EXHIBIT A DRAFT CONDITIONS OF APPROVAL PUD-106

Chrysler-Jeep-Dodge Staples Ranch August 27, 2014

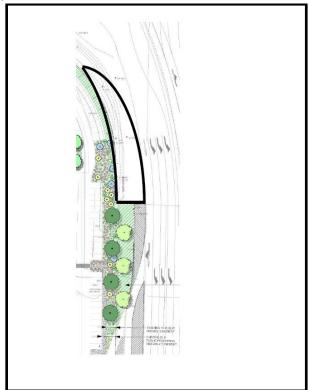
- 7. Construction of the western exit between Lot 1 and Lot 2 shall occur when Lot 1 is developed and shall accordingly be reflected on plan check plans submitted to the Building and Safety Division.

- 8. Construction of the drive aisle that runs east-west and is located between Lots 1 and 2 shall occur when Lot 1 is developed and shall accordingly be reflected on plan check plans submitted to the Building and Safety Division.
